CITY OF ALBUQUERQUE

Planning Department
David Campbell, Director

RE: **Lot 1 Block 9 Unit 22 Volcano Cliffs SAD 228**
6444 Picardia NW
Grading and Drainage Plan
Engineers Stamp Date 8/18/18 (D10D003Q01)

| DAVID SOULE NEW MEXICO REGISTERED PROFESSIONAL ENGINEER 8/18/18 | GRADING AND DRAINAGE PLAN | DATE: 8-17-18 |

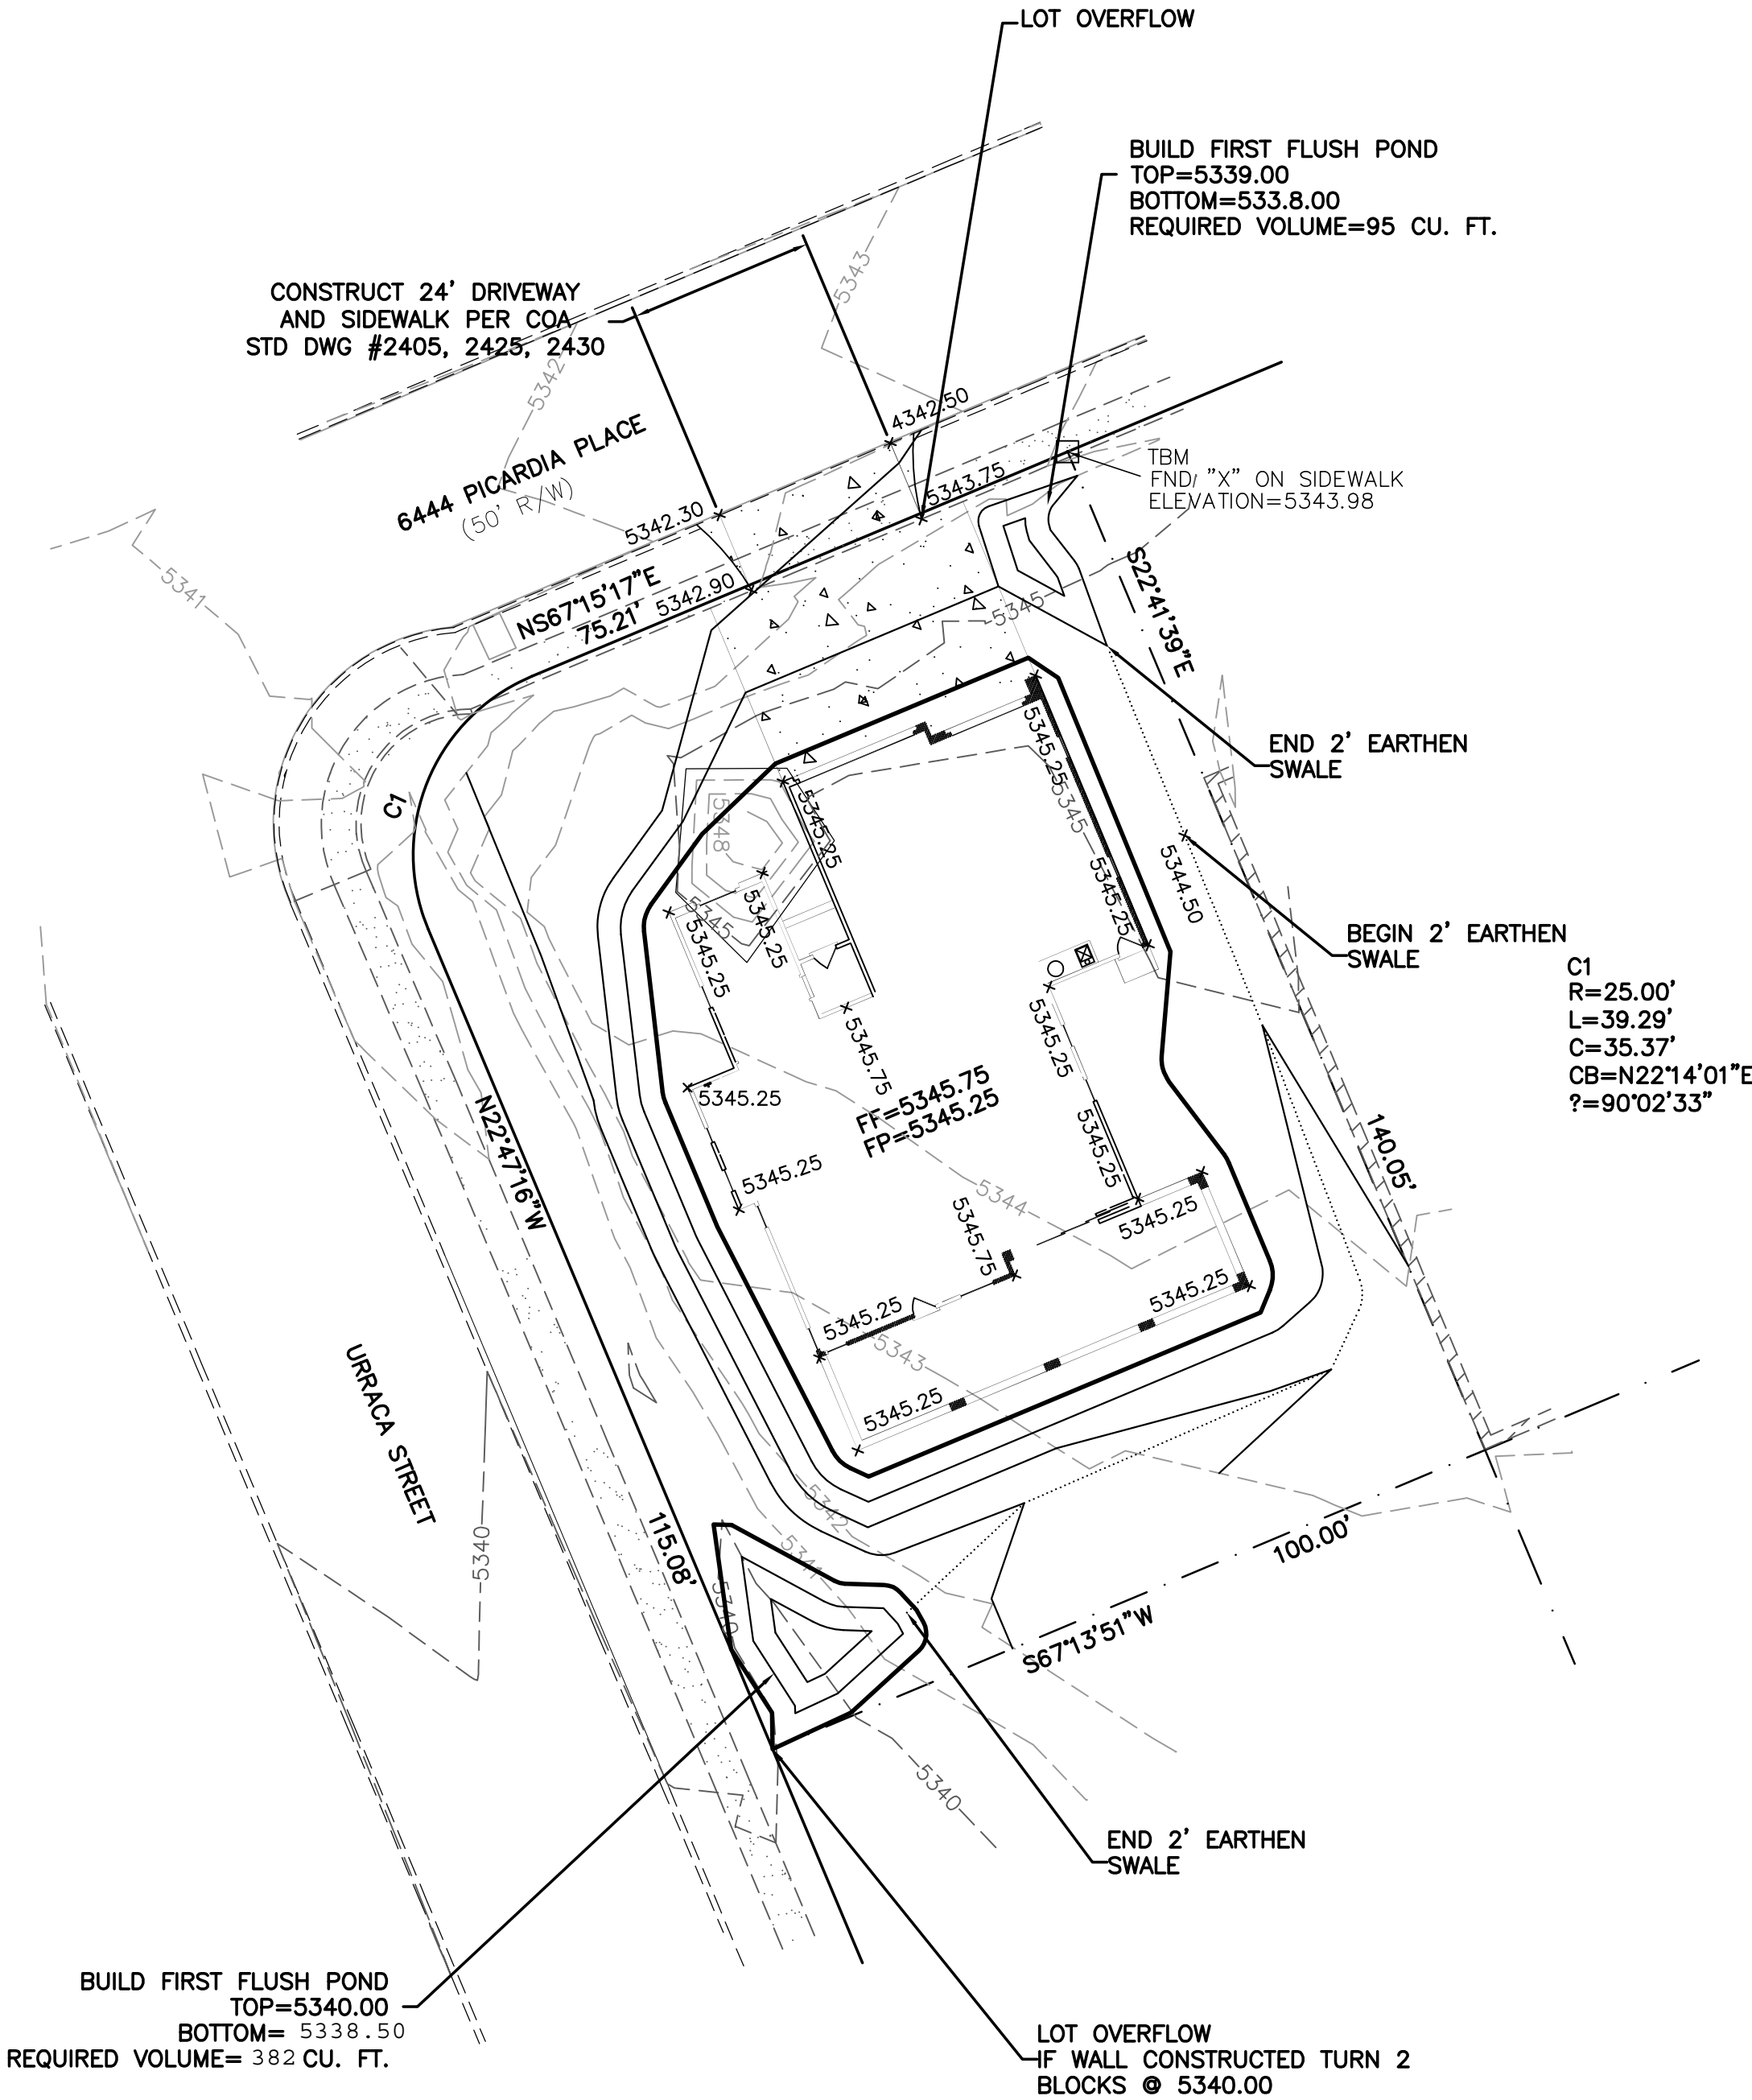
- Remove the dirt from the street being used as a ramp.
- Remove dirt piles on the sidewalk.
